**CALIBRATOR CATHODE FOLLOWER
RESISTOR ADDED TO ASSURE
+100V CF OUTPUT LEVEL**

M1001

M1014

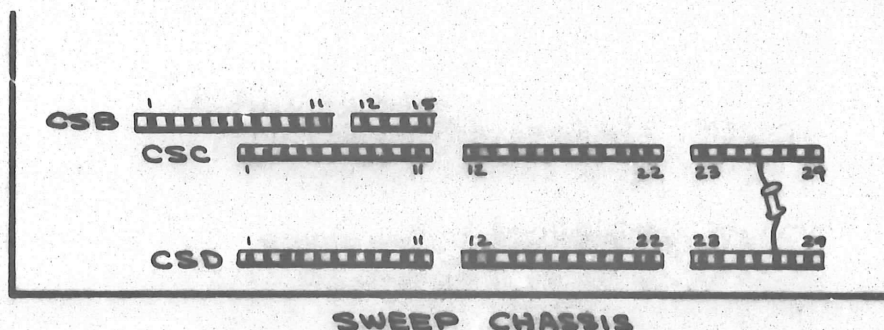
To improve linearity of the sawtooth waveform at high Sweep speeds, a capacitor was added between Miller Generator plates and the cathode of the Cathode Follower to maintain a near-constant current through the loads at all Sweep speeds.

Install C96, an 82pf 500v capacitor, between CSC-26 and CSD-27 on the Sweep chassis.

M1019-2

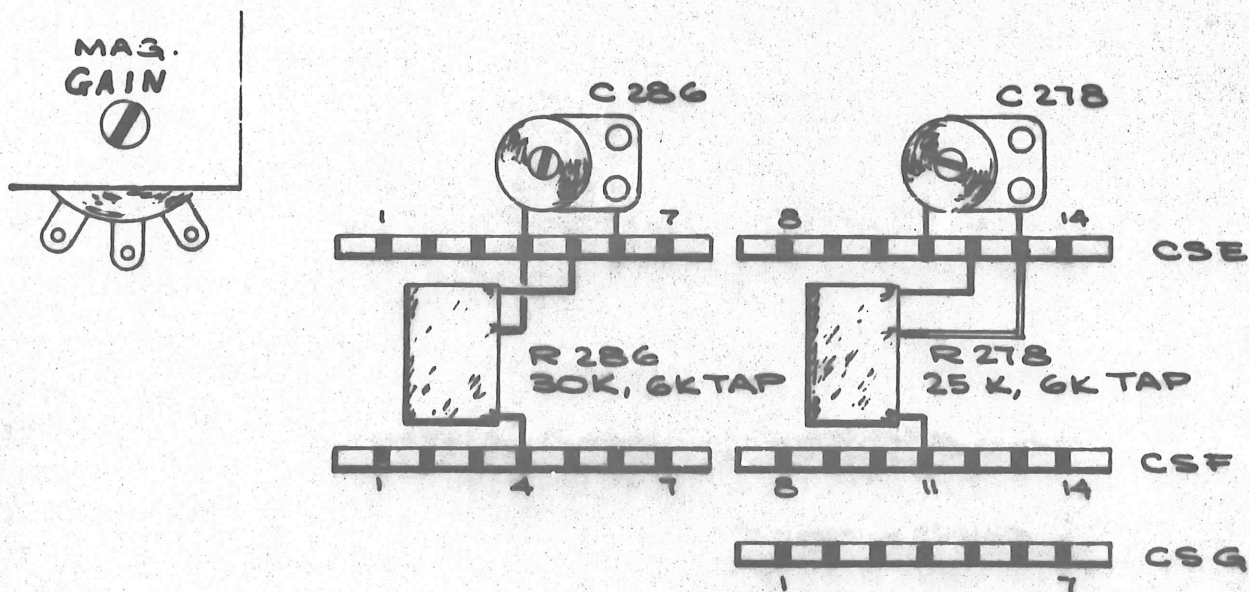
To linearize and improve the Sweep timing in the 0.1 sec/cm and 0.2 μ sec/cm Magnifier positions, the mica plate resistors R278 and R286 were changed to tapped resistors, and two variable capacitors were added between the taps and cathodes of the Sweep Cathode Follower CRT drivers.

- Remove R276 (25 k 8w mica plate resistor) and R286 (30k 8w mica plate resistor), located on the ceramic strips above V265 and V272, respectively, on the Sweep chassis.
- Install R278, a 6-25 k tapped 7w 1% resistor, between CSE and CSF as shown in drawing.
- Install R286, a 6-30k tapped 7w 1% resistor, between CSE and CSF as shown in drawing.
- Install C278 and C286, 3-12pf variable capacitors, on CSE as shown in drawing.

M1041

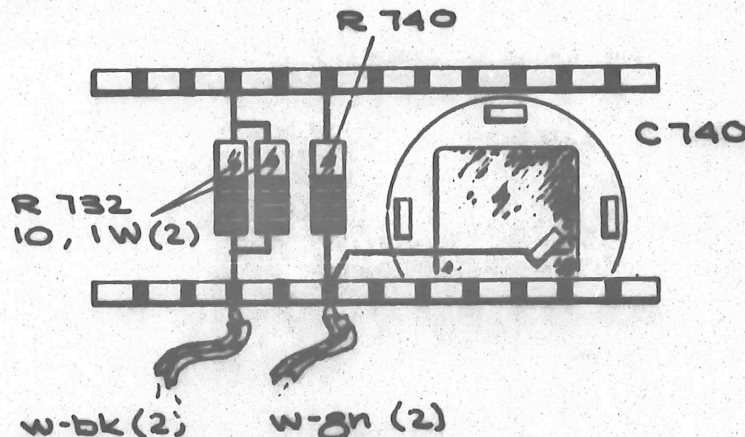
To assure the proper dissipation rating of the 'Current-Measuring' protective resistor in the -150v and +100v supply section of the power supply, the 150v resistor R732 was replaced with two 10 Ω 1w resistors (R732 and R733) in parallel, and the +100v resistor R740 was increased to 1w.

- Replace R732, 10 Ω 2w 10% resistor located on the ceramic strips above C740 on the power supply chassis, with two 10 Ω 1w 10% resistors in parallel.
- Replace R740, 10 Ω 1/2w 10% resistor located on the ceramic strips next to R732, with a 10 Ω 1w 10% resistor.

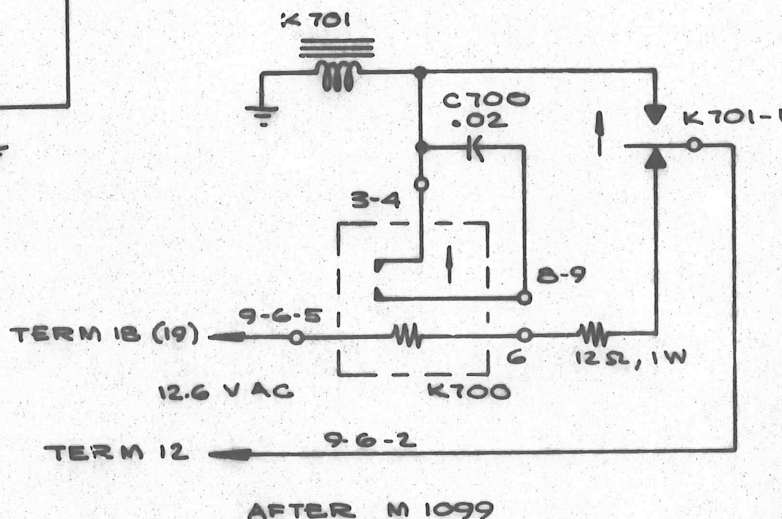
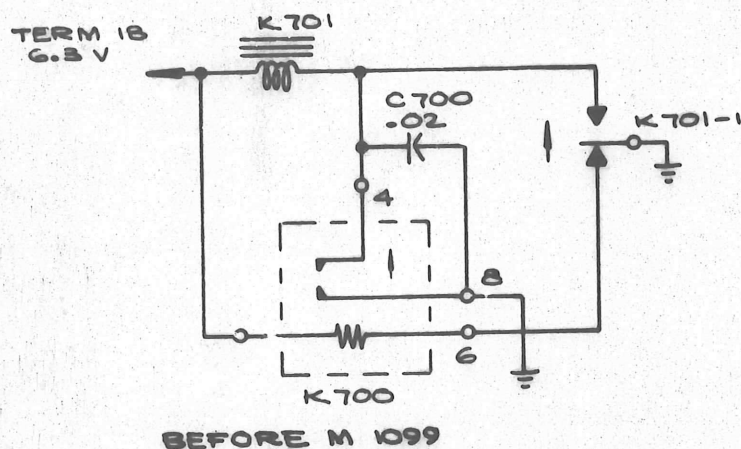
R708, a 12Ω 1w 10% resistor, is added to relay K700. This allows a voltage in excess of 6 volts to be applied to K700 relay, insuring a more positive operation at low AC line voltage. Also overcomes peculiar mechanical characteristics of the relay.

**SWEEP AMP DRIVER CF COMPENSATING
RESISTOR ADDED TO IMPROVE
STARTING CHARACTERISTICS**

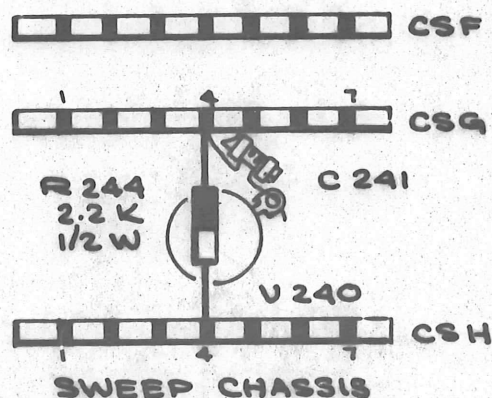
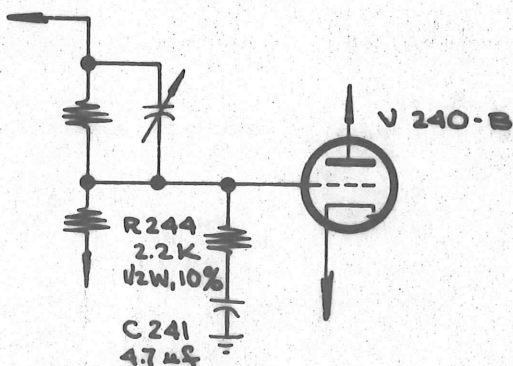
To decrease the starting time of the sweep in the fastest ranges, a resistor was added to the grid circuit of the Driver Cathode Follower V240B in series with C241.

- Remove the bare wire strap between CSG-4 and a ground lug on V240.
- Relocate one end of C241, a 4.7pf 500v capacitor, from CSH-4 to ground lug on V240.
- Install R244, a 2.2k 1/2w 10% resistor, between CSG-4 and CSH-4.

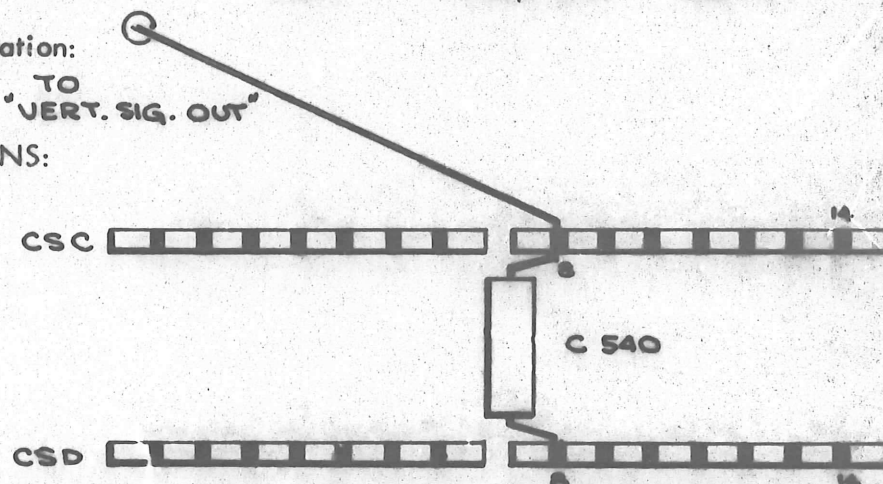
C540 0.022 μ f 400v 285-515

C540 0.022 μ f 600v 285-517

Replace C540, a 0.022 μ f 400v capacitor on the Driver chassis, with a 0.022 μ f 600v capacitors.

CALIBRATOR OUTPUT CONNECTOR

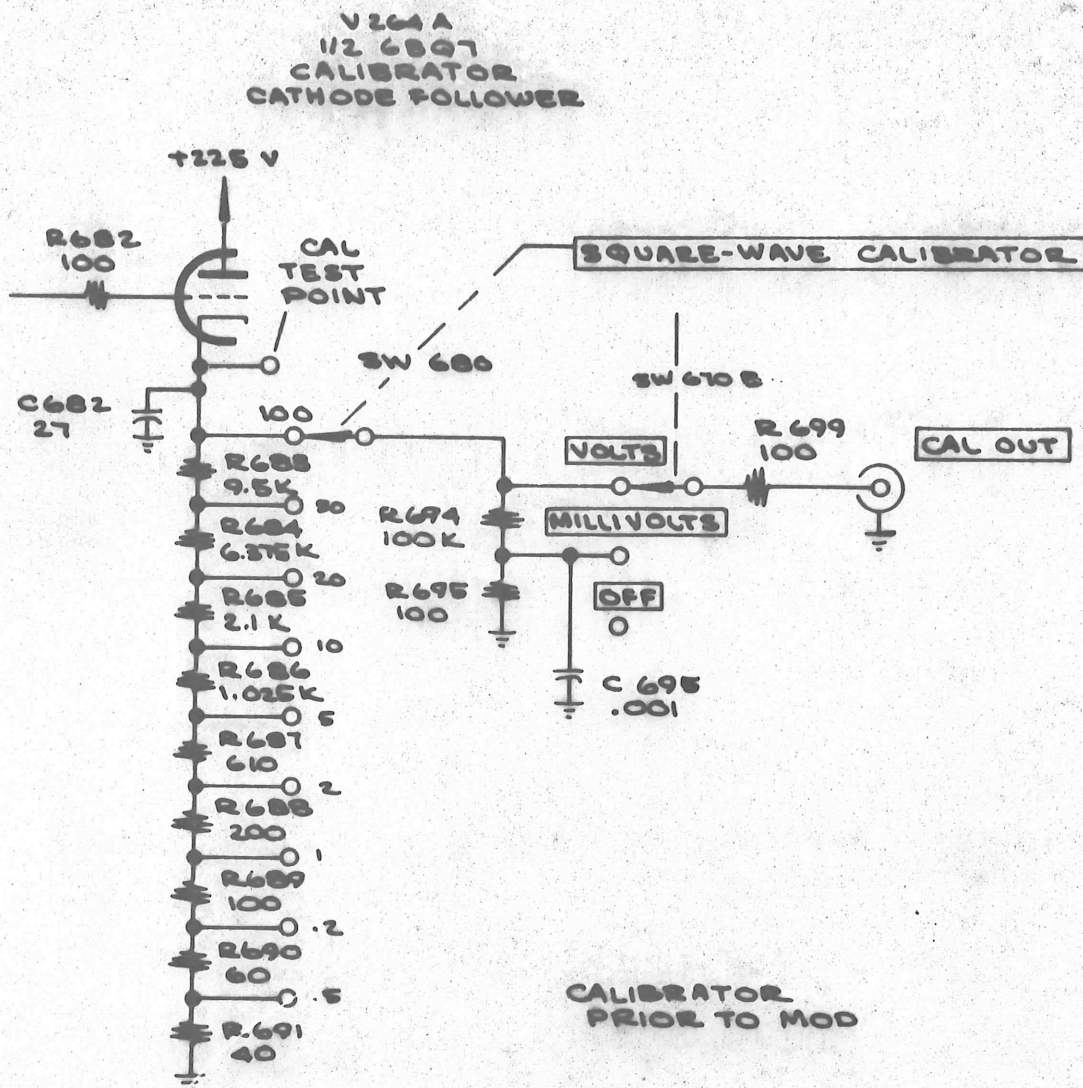
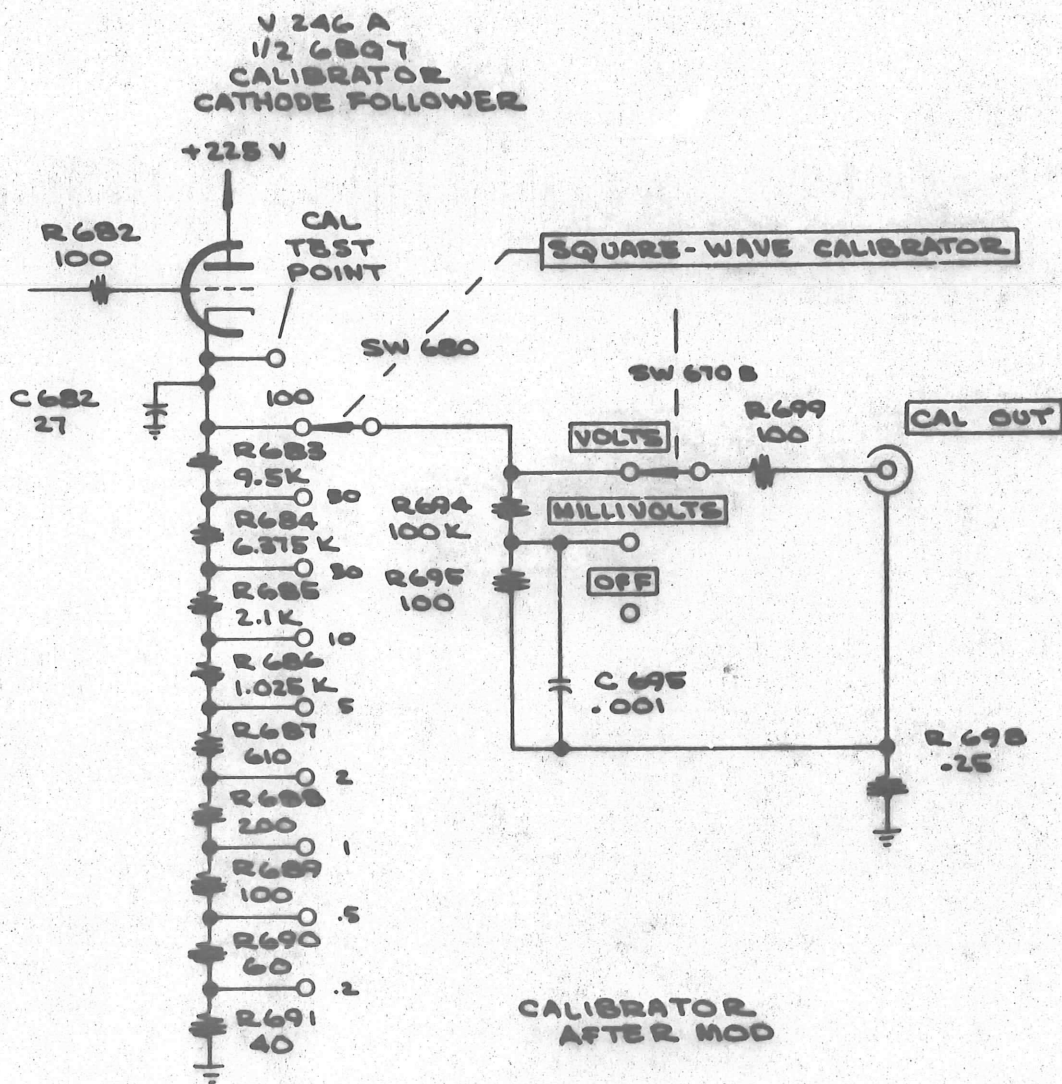
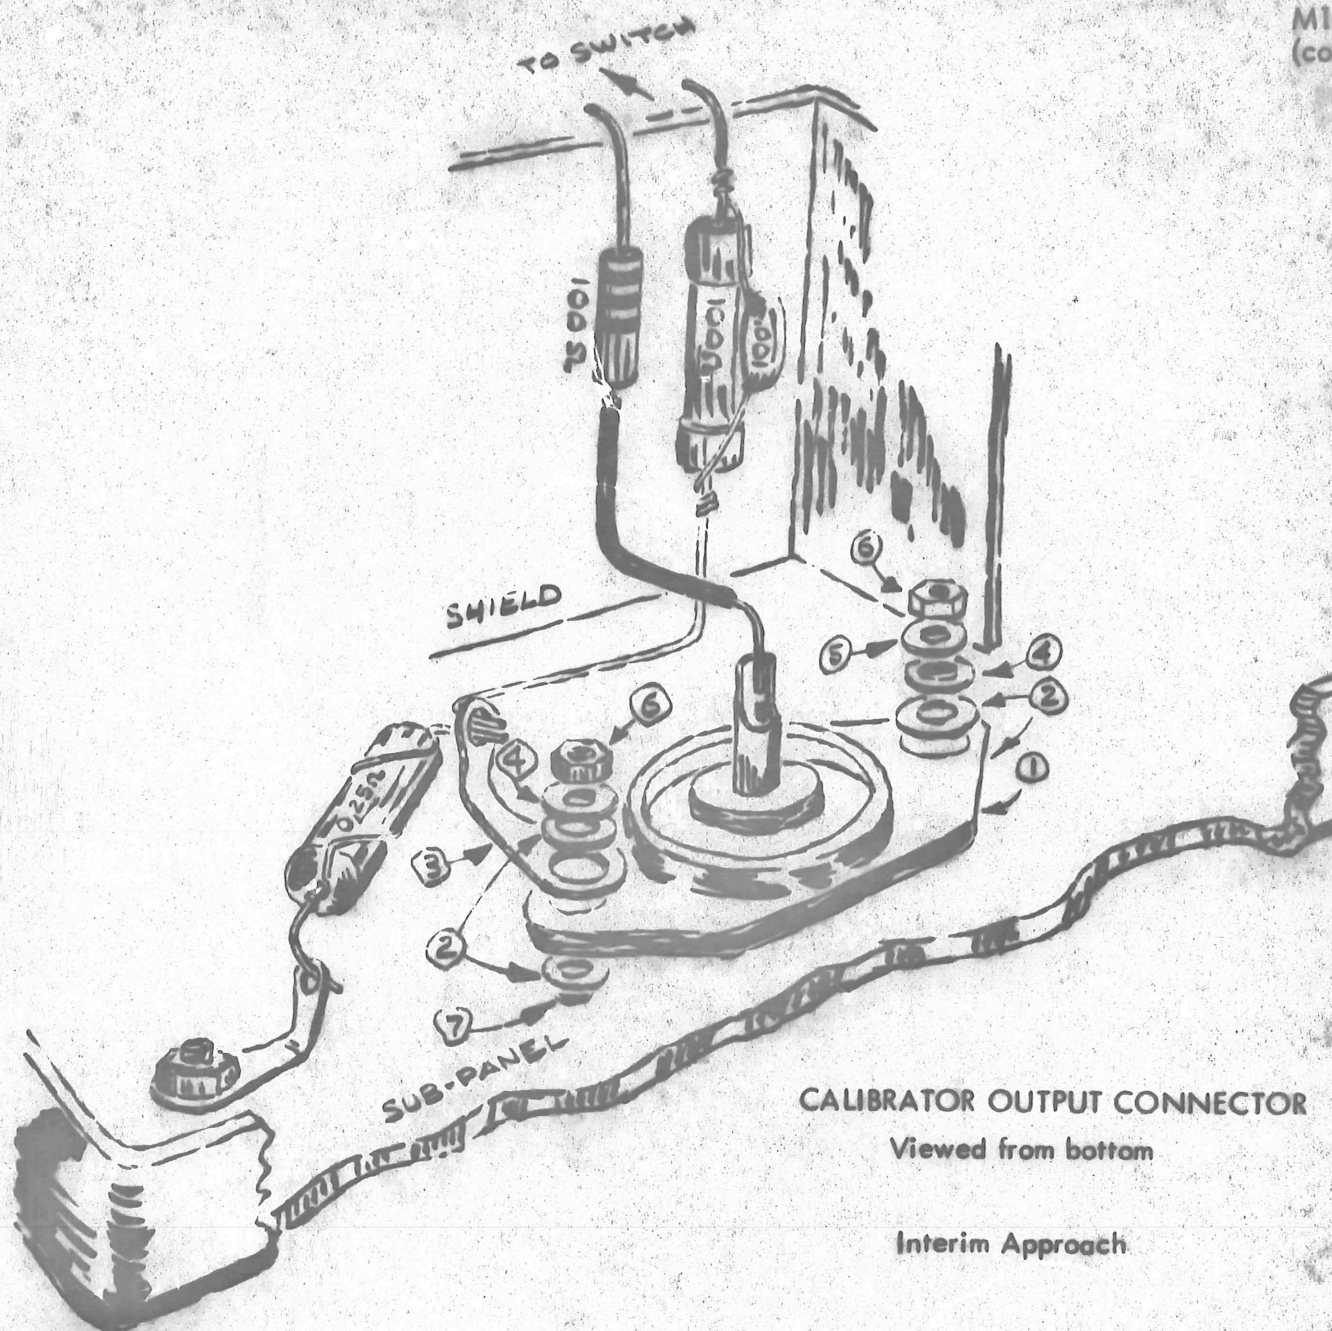
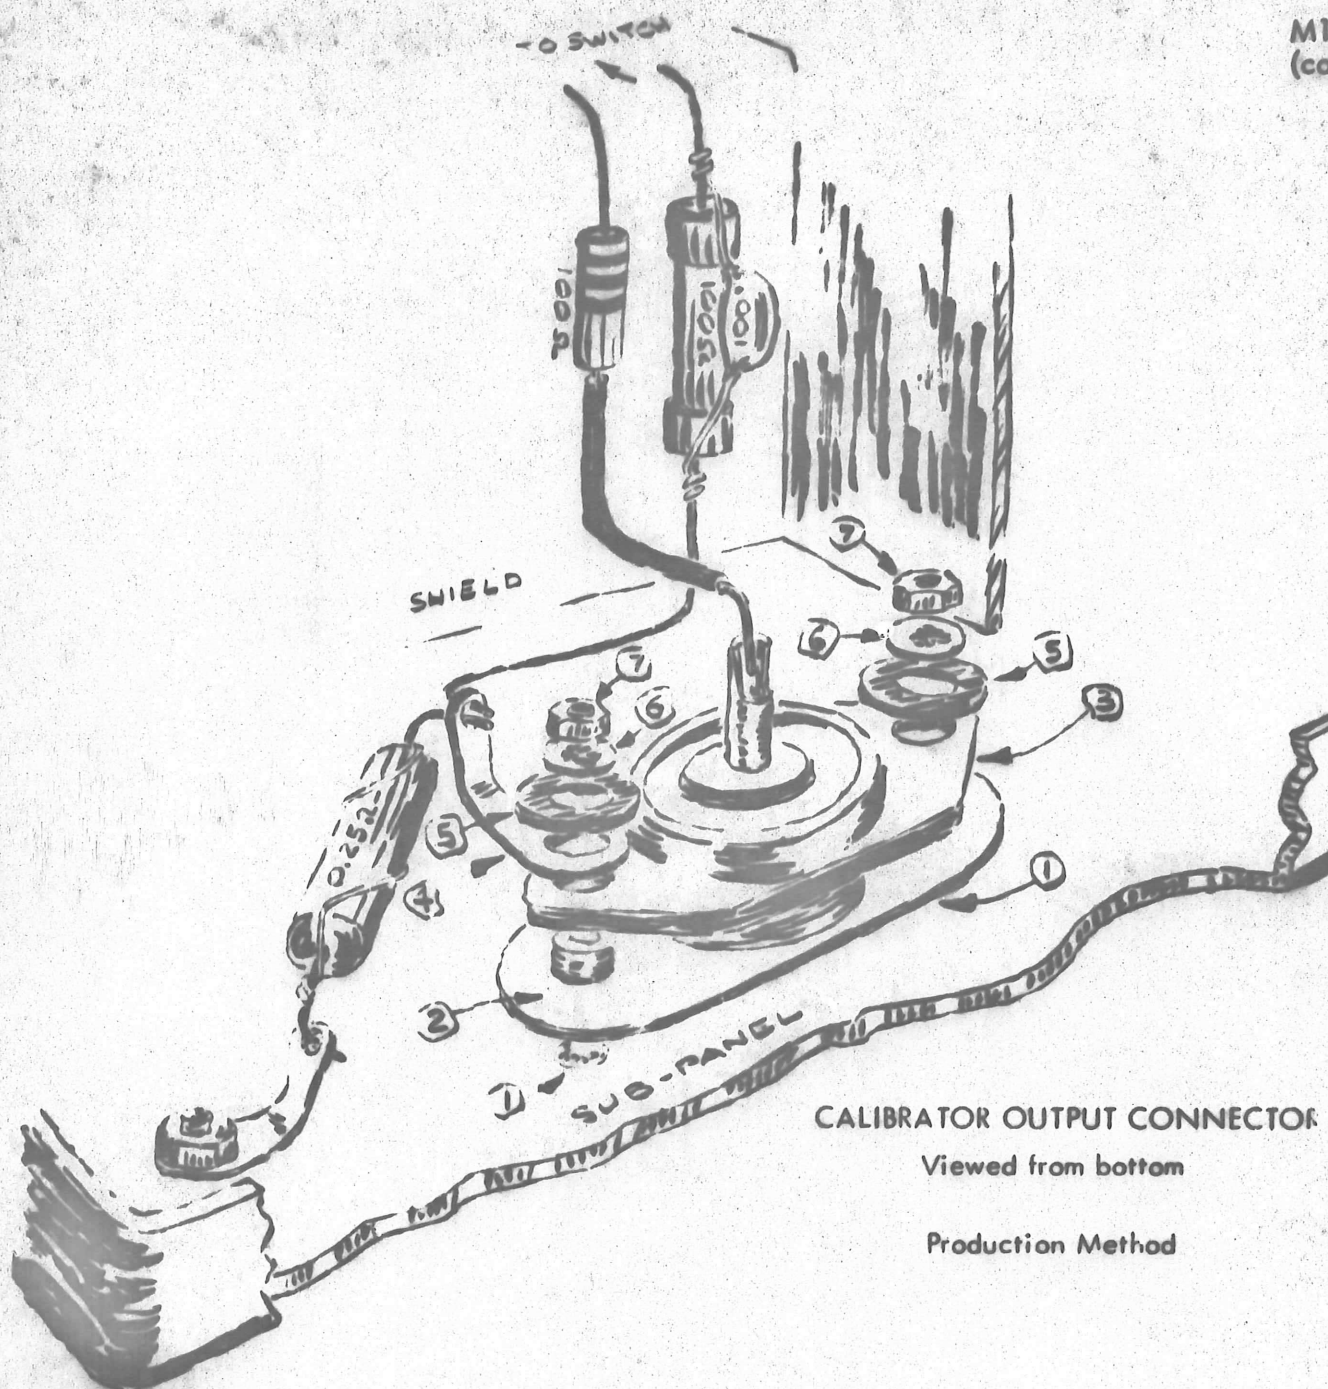
The mechanical changes necessary to the cabinet were included in the cabinet change, M1324, and involved the following:

1)	Connector, modified 83-IRTY	131-064
2)	Washer, fiber, extruded no.4	210-849
3)	Lug, solder, no.10	210-224
4)	Washer, plain, 5S	210-801
5)	Lockwasher, int, no.4	210-004
6)	Nut, hex, 4 x 3/16	210-406
7)	Screw, 4-40 x 3/8 FHS	211-025

1)	Screw, 4-40 x 3/8 FHS	211-025
2)	Insulator, nylon	406-244
3)	Connector, modified 83-IRTY	131-064
4)	Lug, solder, no.10	210-224
5)	Washer, fiber, no.10	210-812
6)	Lockwasher, int, no.4	210-004
7)	Nut, hex, 4 x 3/16	210-406

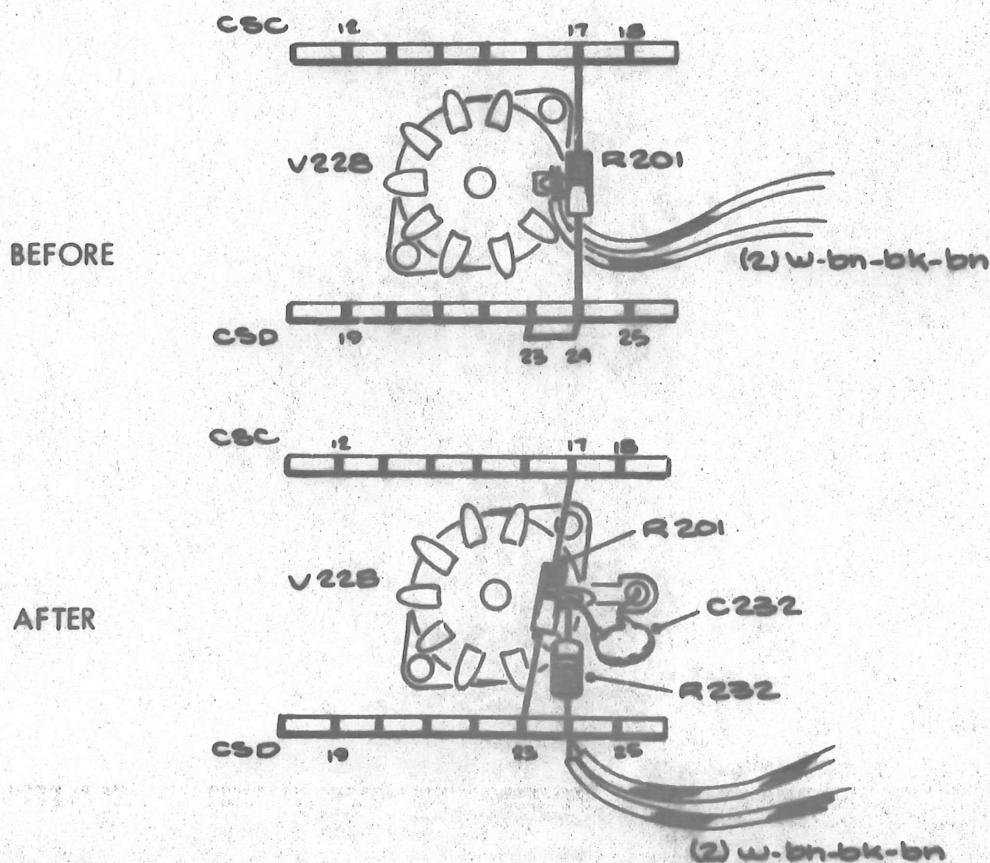
Decoupling was added to the +100 V supply, at the plate of V228B (Delayed Trigger Cathode Follower), to eliminate ringing in the Vertical Amplifier.

- Relocate one end of R201, above V228 on the Delay chassis, from CSD-24 to CSD-23. Remove bare wire strap between CSD-23 and CSD-24.
- Relocate the two white-brown-black-brown wires from pin 1 of V228 to CSD-24.
- Install C232, a 0.005 μ F discap, between pin 1 of V228 and its socket ground lug.
- Install R232, a 47 Ω 1/2W resistor, between pin 1 of V228 and CSD-24.

**DELAY PICKOFF JITTER ELIMINATED
BY ADDING CAPACITOR TO
DELAY TIME SWITCH**

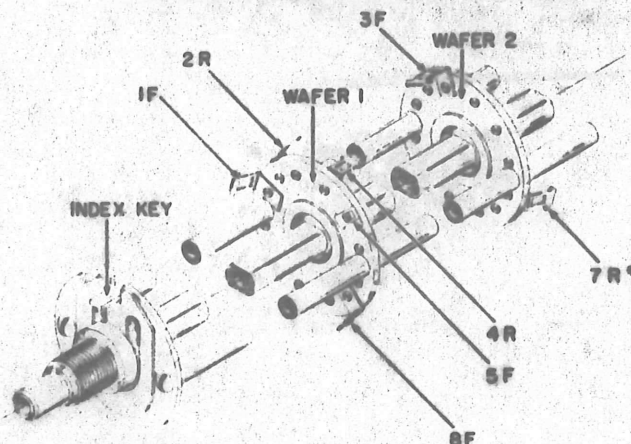
C148D, a 22pF 500V capacitor, was added to the DELAYING SWEEP TIMING switch to eliminate jitter to the Delay Pickoff. This had the effect of increasing the holdoff time to the 2, 5 and 10 μ s position of SW190A. In instruments prior to s/n 1546, a 47pF 500V capacitor was designated C148D and occupied this same circuit position. See M1123.

- a) Install C148D, 22pF 500V capacitor, between the rear potentiometer mounting plate and W3-2R on the DELAY TIME/CM switch.
- b) Below s/n 1546 only --
Replace C148D, 47pf capacitor, on the DELAY TIME/CM switch with a 22pF 500V capacitor.

NOTE: The following method is used to identify the DELAY TIME/CM switch terminals:
